### **Council File Number 15-0317-- Case No. BF 140090 Appeal for 3923-3941 North Hopevale Drive**

Re: Council File No. 15-0317 - Case No. BF 140090  
3923 – 3941 Hopevale Drive – Haul Route Appeal

### **GRADING QUANTITY STUDY FOR 3923 HOPEVALE DRIVE CITY OF LOS ANGELES APRIL 10, 2015**

# EXHIBIT B

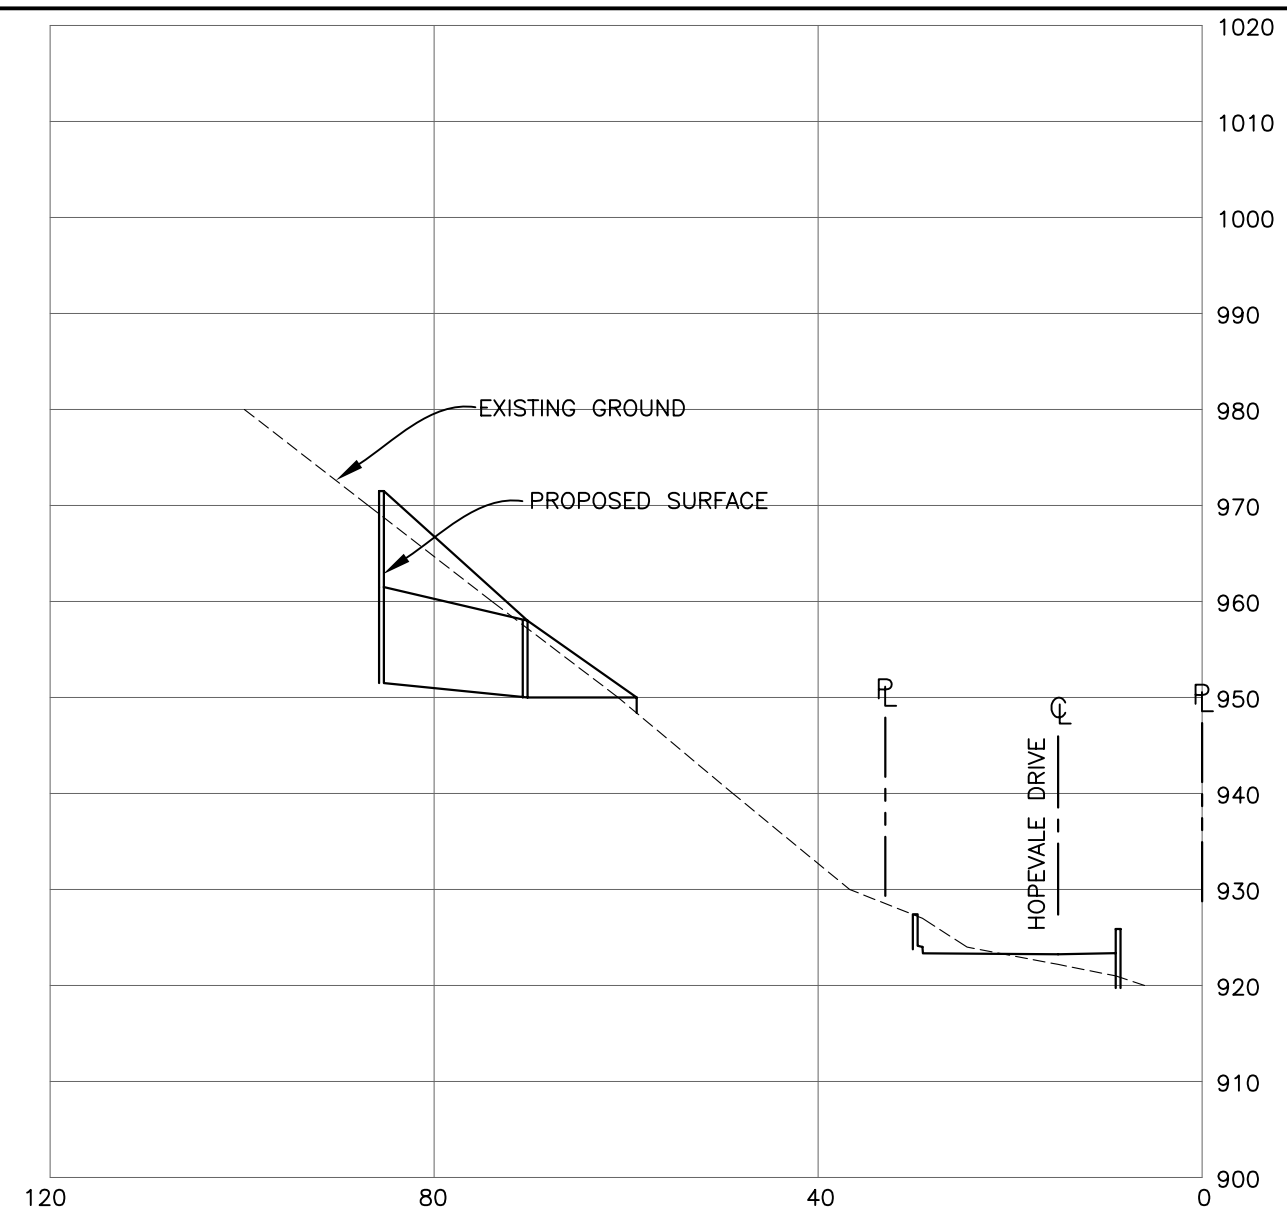
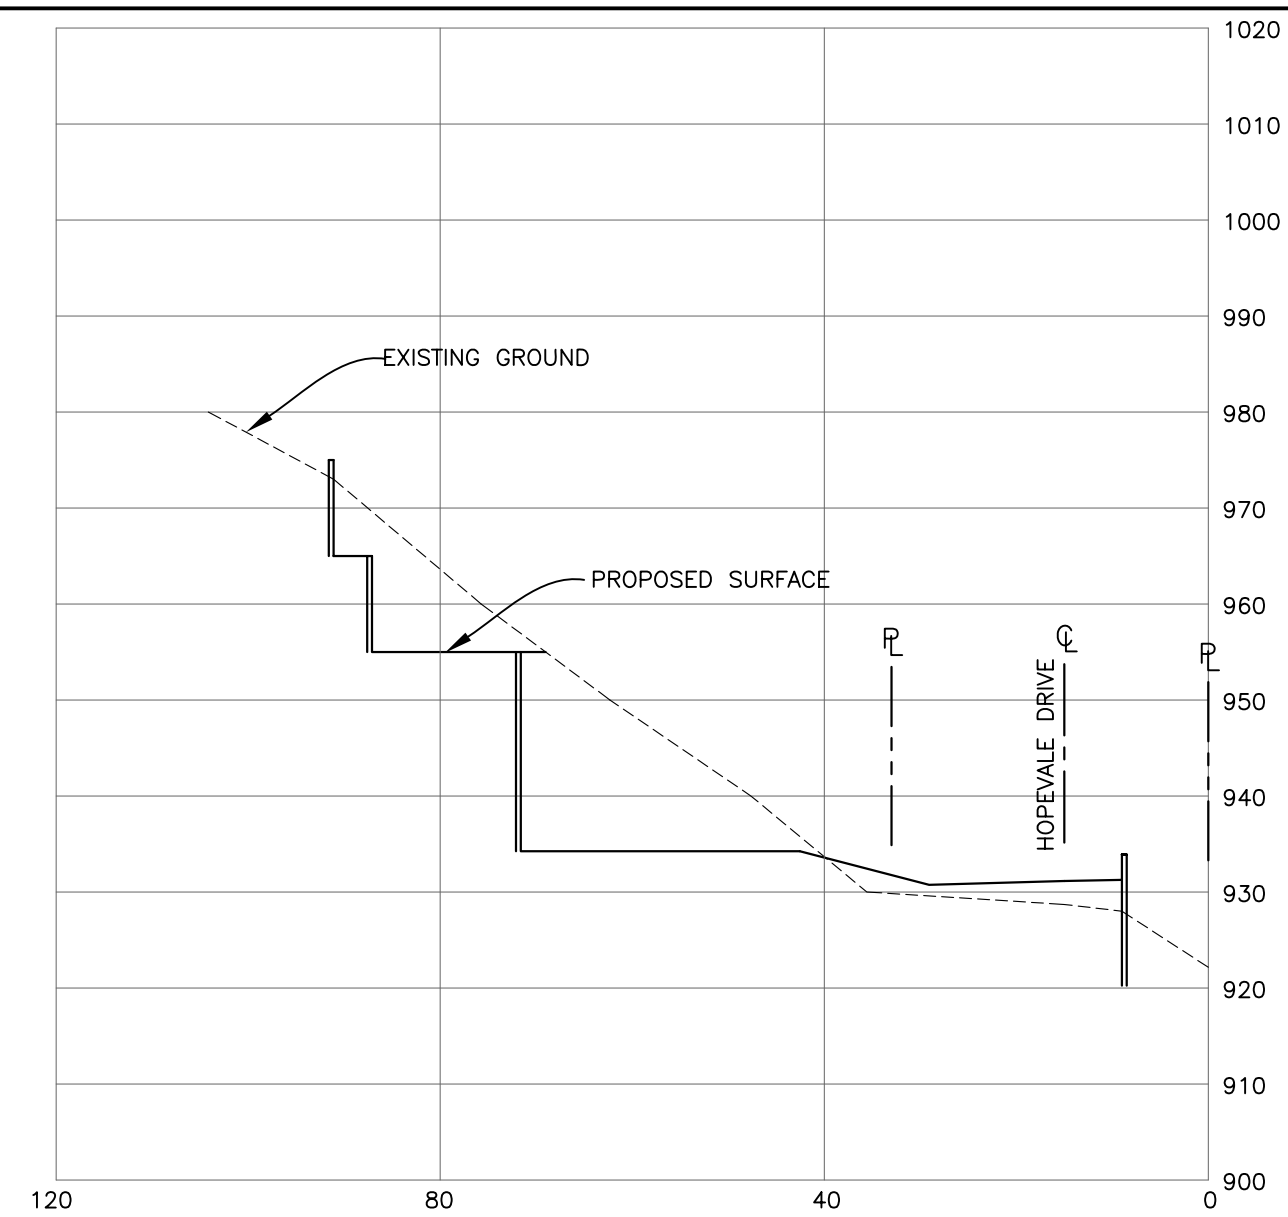
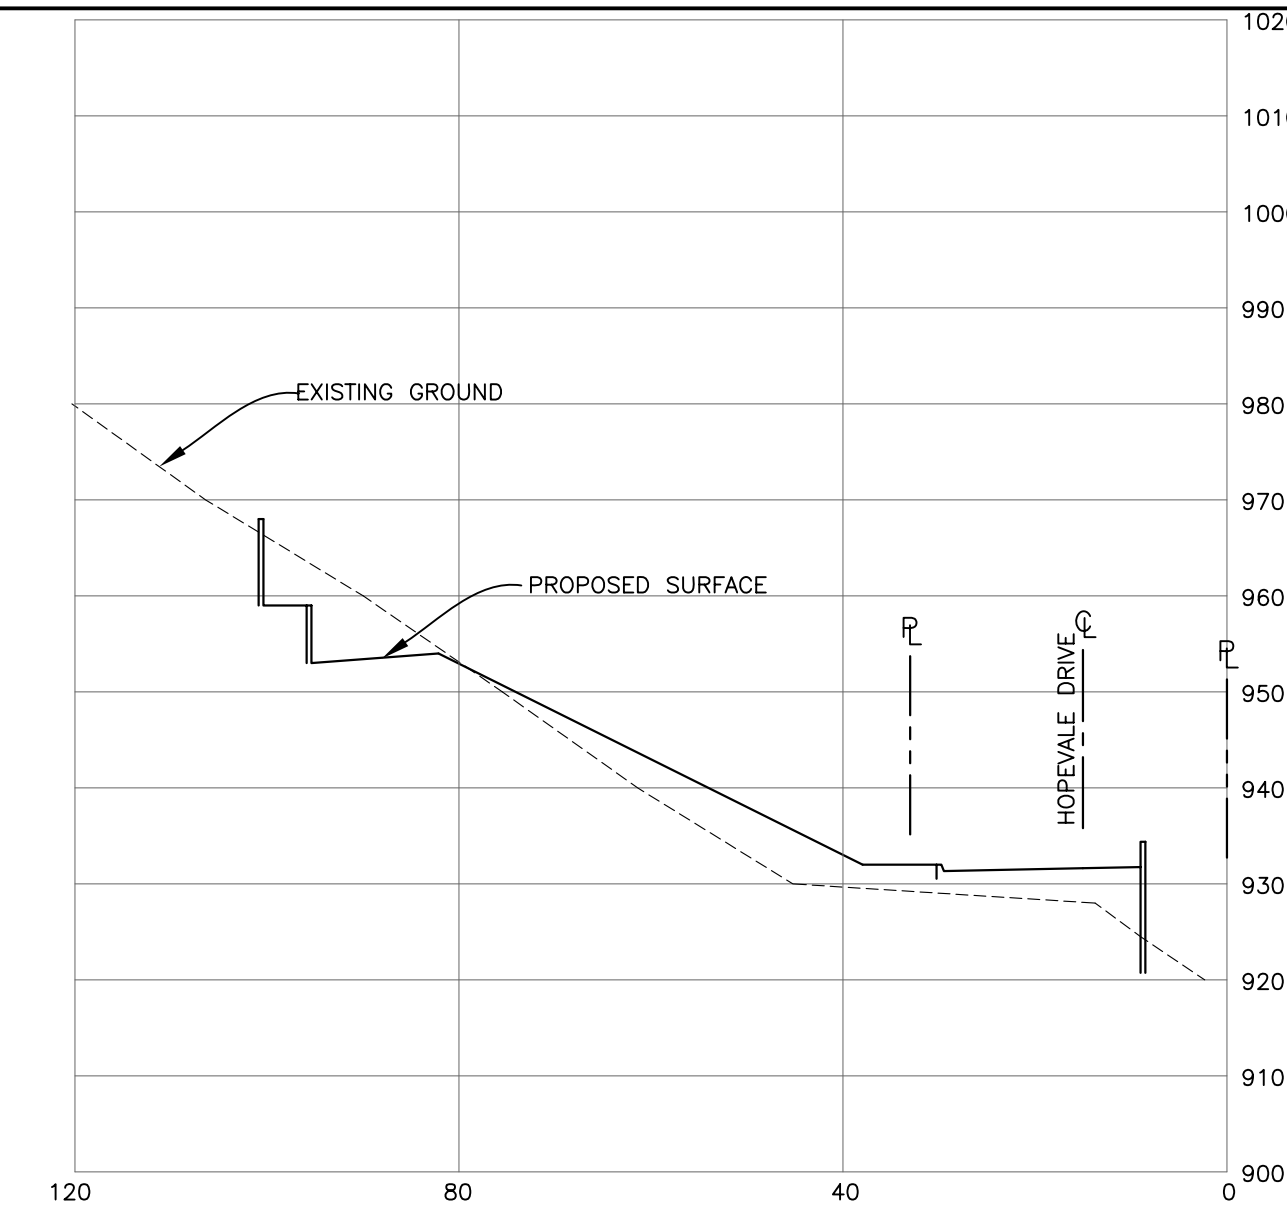
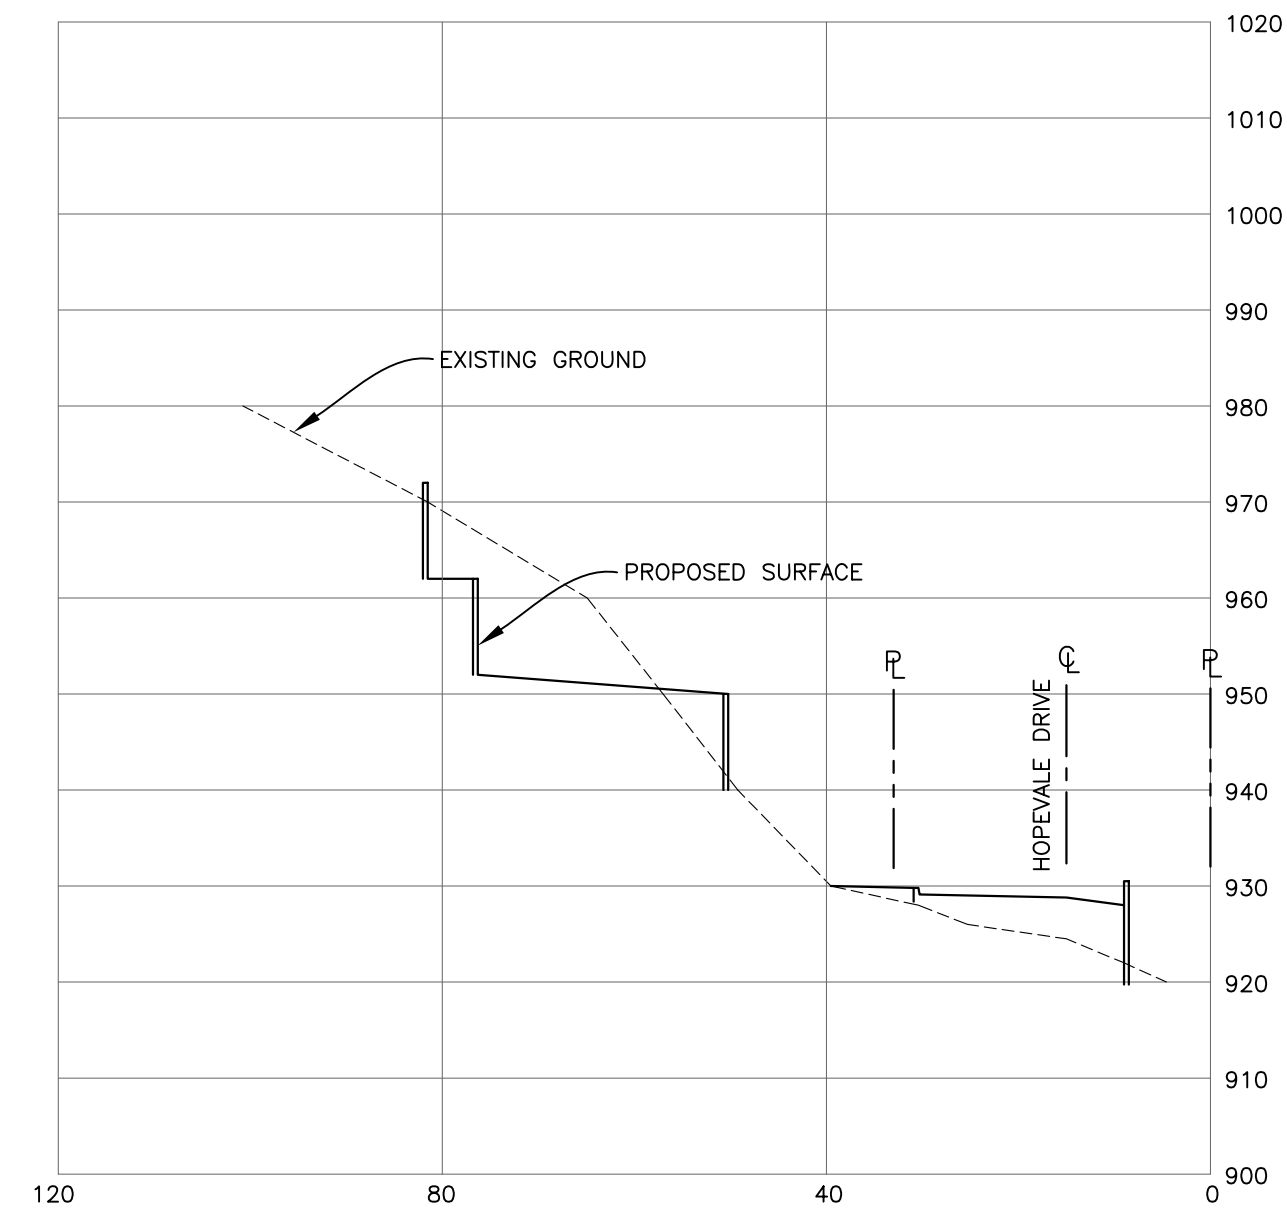
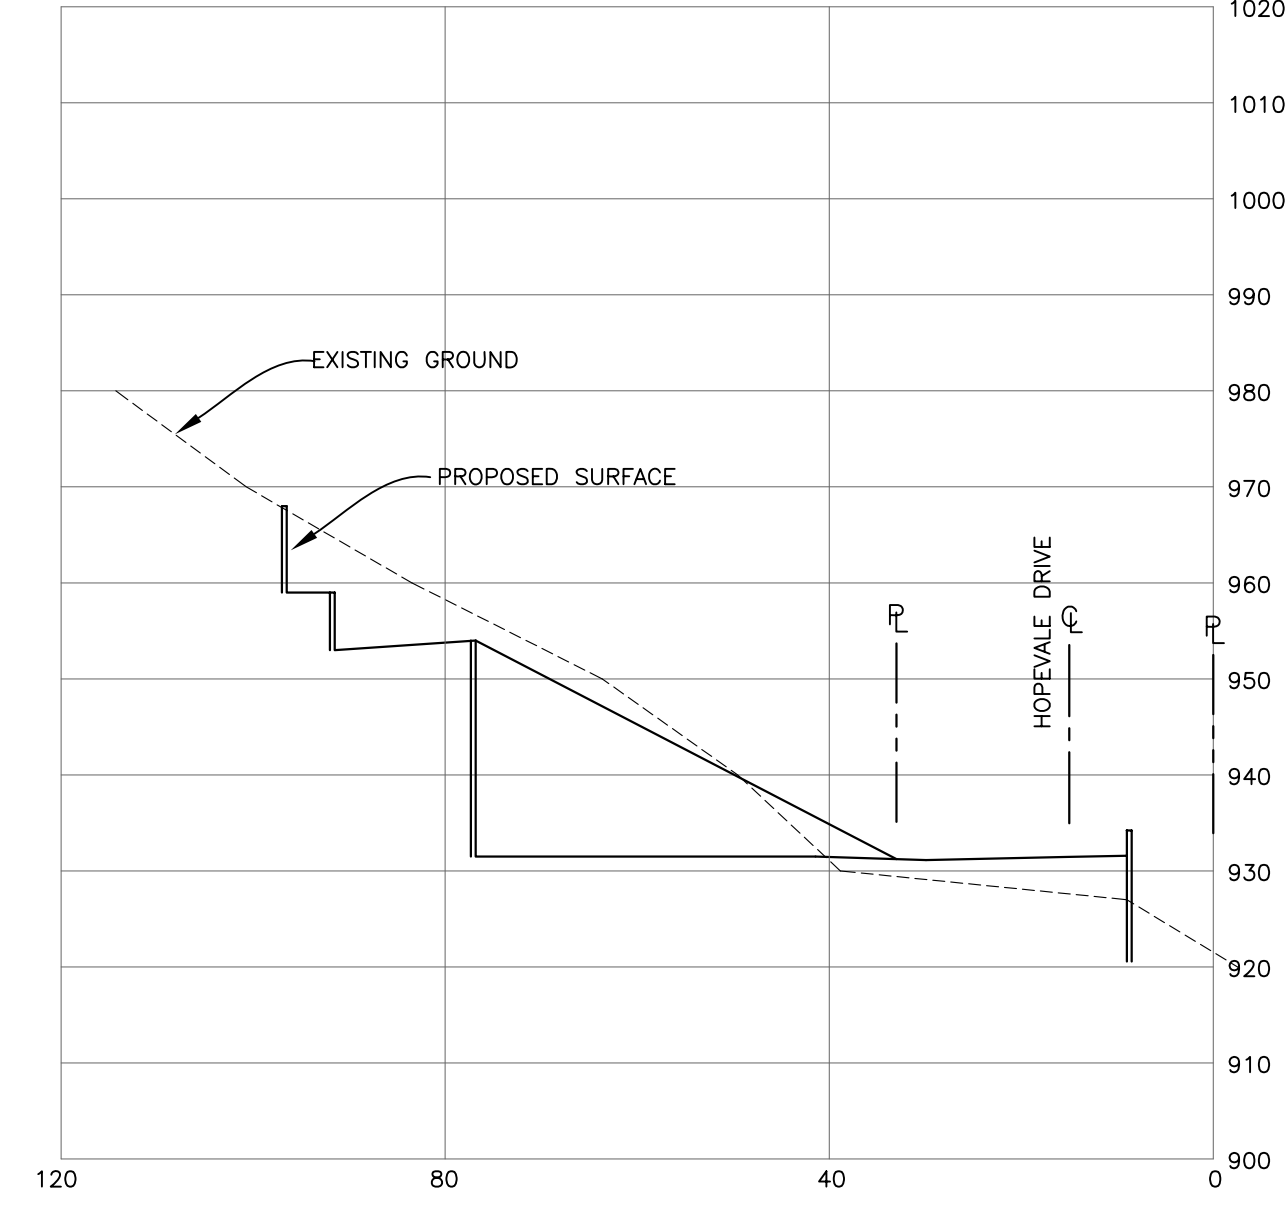
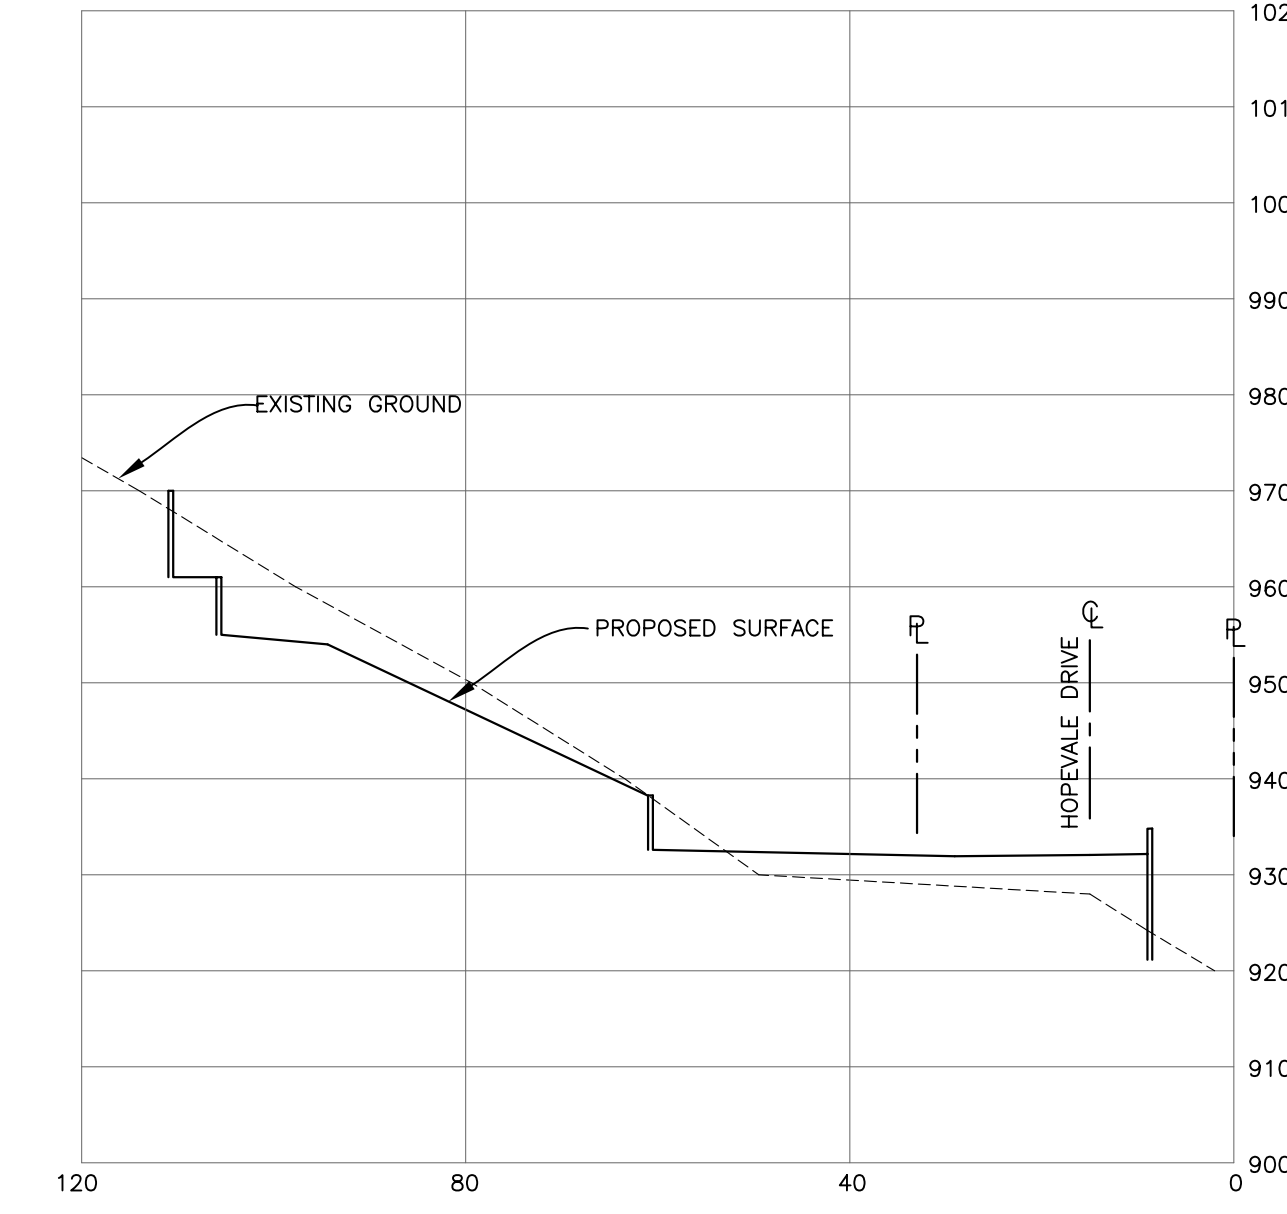
**NOTE**  
THE EXISTING GRADE SURFACES SHOWN HEREON FOR ELEVATIONS 928 AND BELOW (IN THE STREET AREA) WERE TAKEN FROM APPROVED STREET PLAN P-36633 AND DO NOT MATCH THOSE SHOWN ON THE PROPOSED GRADING PLAN. THE EXISTING GRADE SURFACES SHOWN HEREON FOR ELEVATIONS 930 AND ABOVE WERE TAKEN FROM THE PROPOSED GRADING PLAN.
